STATE OF VERMONT
AGENCY OF TRANSPORTATION

PROPOSED IMPROVEMENT
BRIDGE PROJECT

TOWN OF STOWE
COUNTY OF LAMOILLE

RECORD PLANS

APPROACH SLAB #1 PLAN

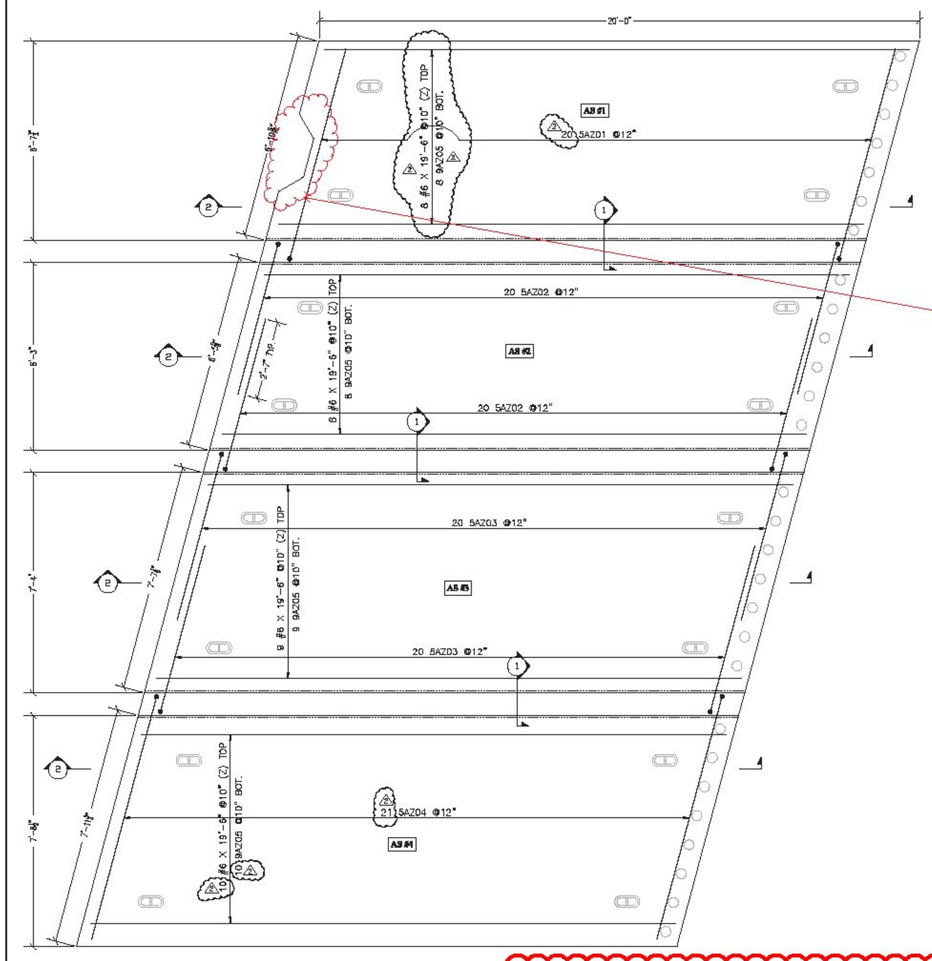
See sheet 3 of 4. Per email, blockout dimensions will follow contract plan dimensions.

ABUTMENT #1 ELEVATION
PILES, PILE CAVITIES AND POST TENSIONING DUCKS NOT SHOWN FOR CLARITY

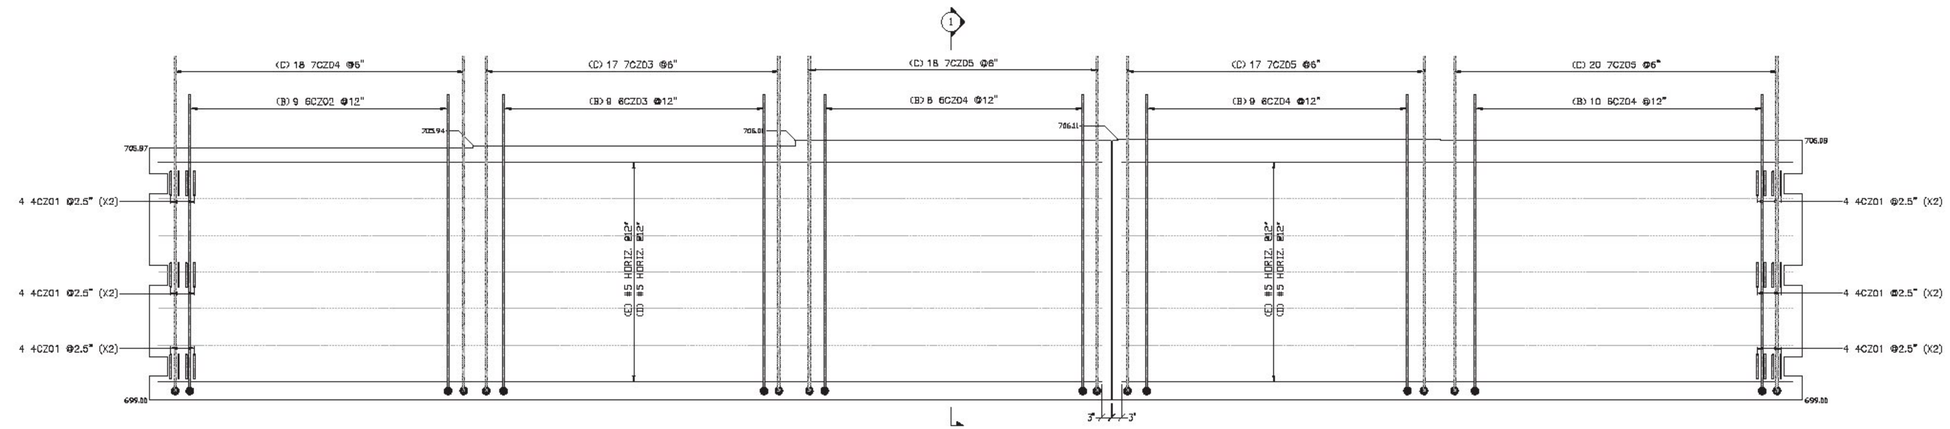
As indicated in previous submittal, this vertical bar is a #5 per contract plans sheet #42 of 64. The #7 bar is a horizontal bar into the page as shown in end section A-A.
